Docket Item #2
Design Review Board Case #2009-0002 (Advisory only)
EESAP Blocks 11 & 12 - 2210 Eisenhower Avenue

Purpose of Application	
Concept design review of a development proposal for two blocks in the Eisenhower East Small Area Plan area. The proposal includes construction of two residential mixed-use buildings at the intersection of Port Street and Eisenhower Avenue adjacent to the Eisenhower Metro Station.	
Staff Reviewers:	Thomas Canfield, AIA tom.canfield@alexandriava.gov Natalie Sun, AICP, LEED AP natalie.sun@alexandriava.gov Gary Wagner, RLA gary.wagner@alexandriava.gov

DESIGN REVIEW BOARD ACTION, NOVEMBER 19, 2009: The Eisenhower East Design Review Board had significant concerns about some aspects of the concept design and recommended that the applicant revise the proposal for review. The Board recommended that the applicant have a design worksession with the DRB. The Board offered the following design suggestions:

Staff Parti Study showing alternate massing strategy

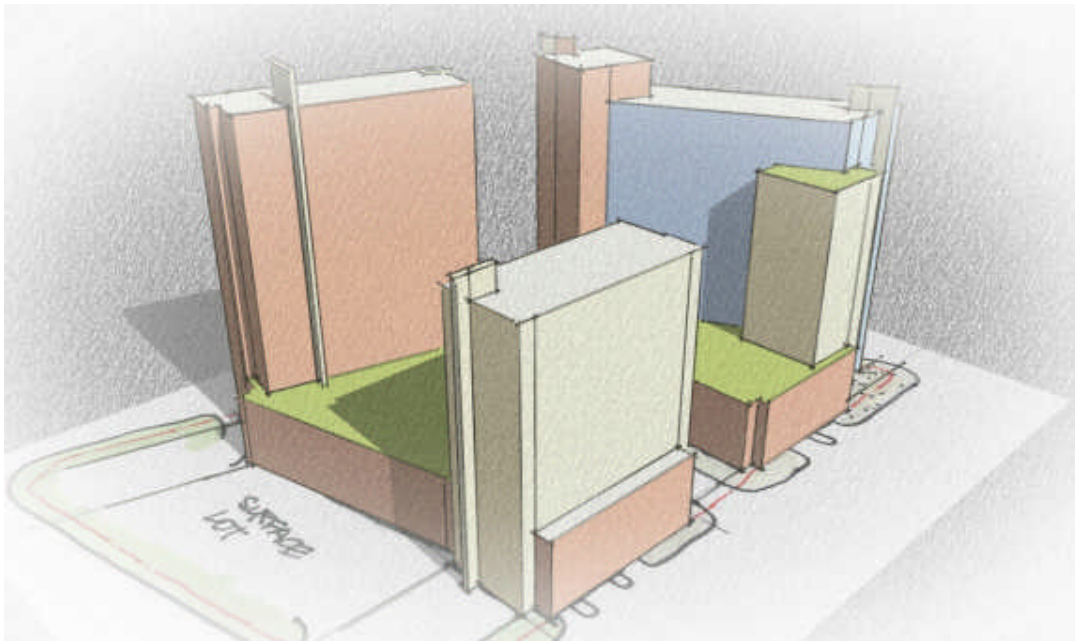
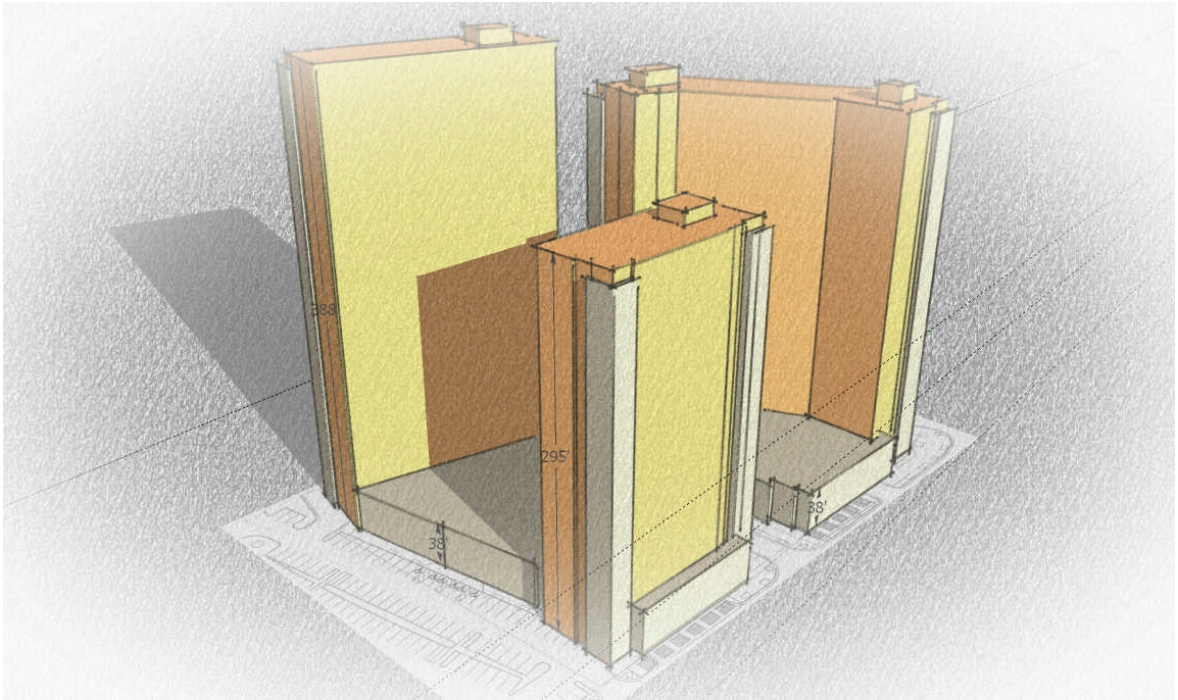
Prior to the July DRB hearing, staff analyzed the applicant's proposal through a series of parti diagrams included in Attachment A of the July DRB staff report (See Attachment F). The parti for the adjacent Lane project on Blocks 19 and 20, for example, is a geode concept in which unified open space courtyards form a north-south axis that splits the buildings, revealing glassy internal façades. Absent from the current Blocks 11 and 12 proposal is a concept that would, for example, provide a rationale for materials expression/selection throughout all buildings, design treatment of courtyard versus street-facing facades, tower articulation/expression, or how the buildings address the highly variable contexts that surround the site. See Attachment C for the applicant's parti progression and staff's parti study.
